HISTORIC AND DESIGN REVIEW COMMISSION

HDRC CASE NO: 2020-397
ADDRESS: 822 E MAGNOLIA AVE
LEGAL DESCRIPTION: NCB 6530 BLK 2 LOT 28
ZONING: R-4, H
CITY COUNCIL DIST.: 1
DISTRICT: River Road Historic District
APPLICANT: John & Margaret Day Hertz
OWNER: John & Margaret Day Hertz
TYPE OF WORK: Driveway modifications
APPLICATION RECEIVED: August 28, 2020
60-DAY REVIEW: Not applicable due to City Council Emergency Orders
CASE MANAGER: Rachel Rettaliata

1. Replace existing partial ribbon driveway with a fully concrete driveway.
2. Widen the existing driveway apron by 12 inches.

PROPOSED DRIVE

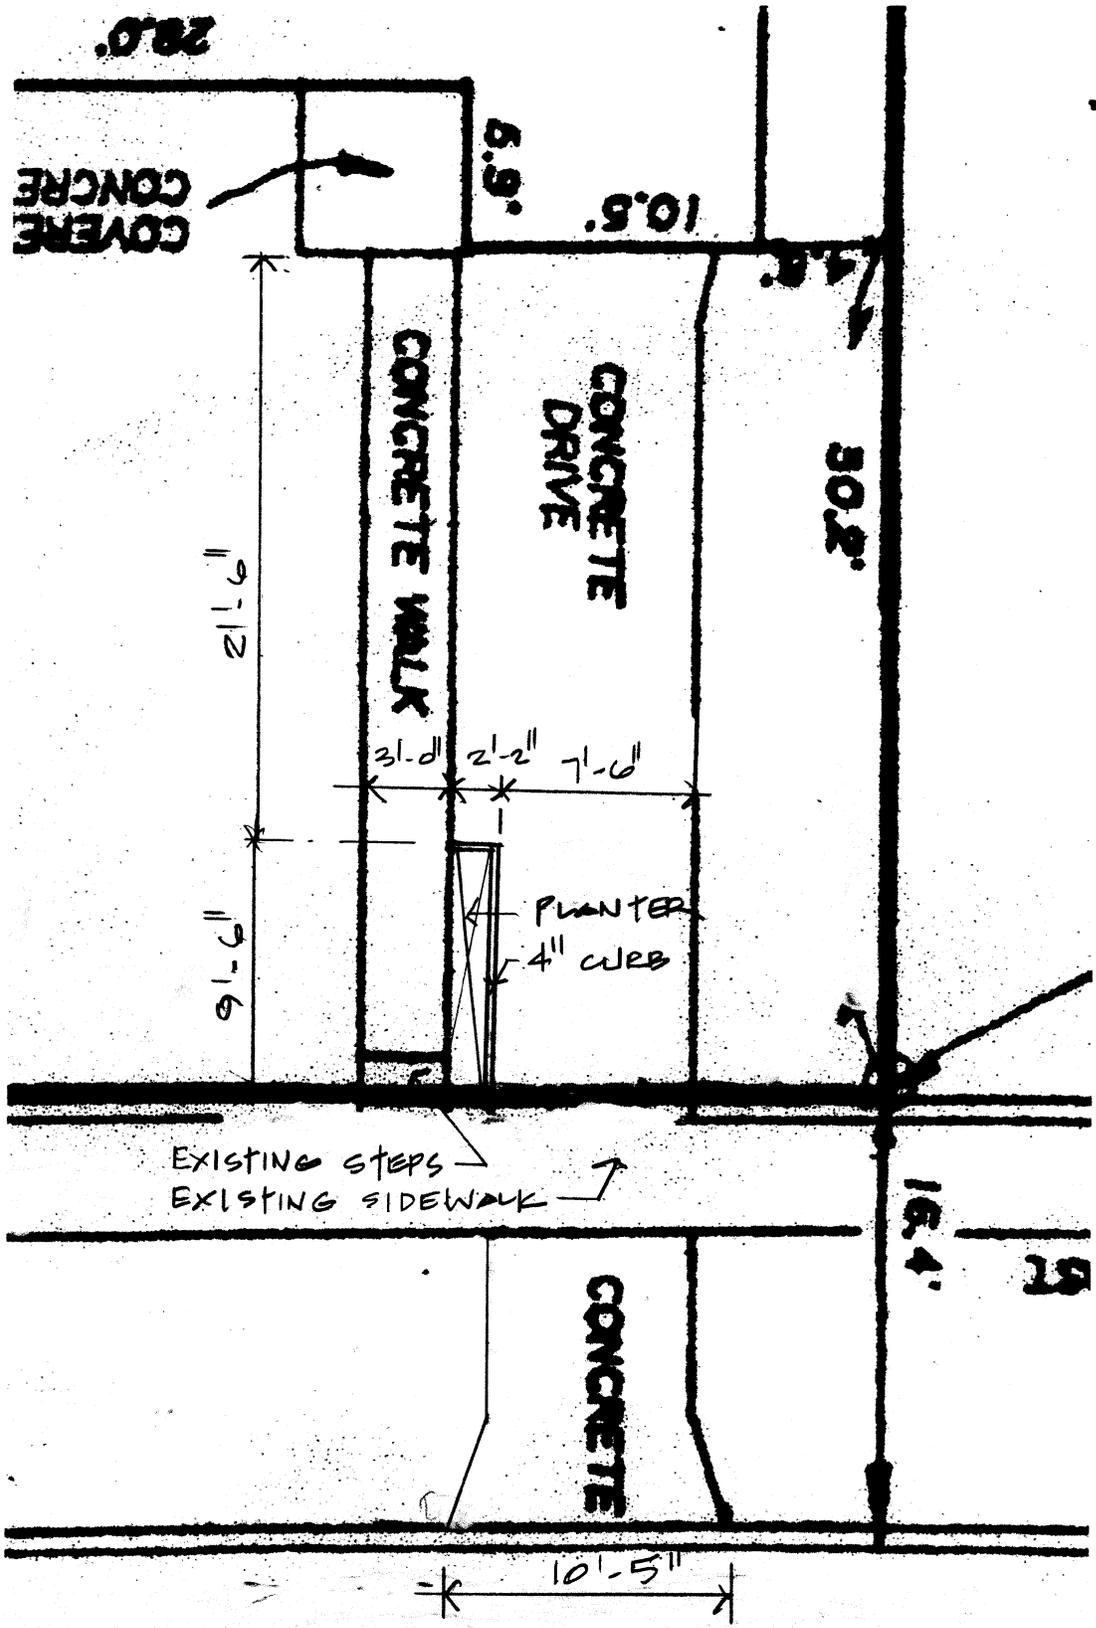
- b. **DRIVEWAY REPLACEMENT** – The applicant has proposed to install a fully concrete driveway to replace the existing modified ribbon driveway. Guideline 5.B.i for Site Elements states that historic driveway configurations should be retained and repaired in place. The 800 block of E Magnolia features full ribbon driveways, fully concrete driveways, and unpaved driveways. The existing driveway has been modified and features concrete slabs that fill the upper portion of the ribbon driveway. Due to the existing modifications, staff finds the proposal appropriate.

- c. **DRIVEWAY APRON MODIFICATION** – The applicant has proposed to widen the existing concrete driveway apron by 12 inches for a total width of 10' - 5". According to Guideline 5.B.ii for Site Elements, the replacement of historic driveways should maintain the width and configuration of original curb cuts and applicants should avoid introducing new curb cuts where not historically found. As the existing curb cut is unusually narrow and is broken and requiring repair, staff finds the proposal appropriate.

Item 1, Staff recommends approval of driveway replacement based on finding b.

Item 2, Staff recommends approval of widening the driveway apron based on finding c.
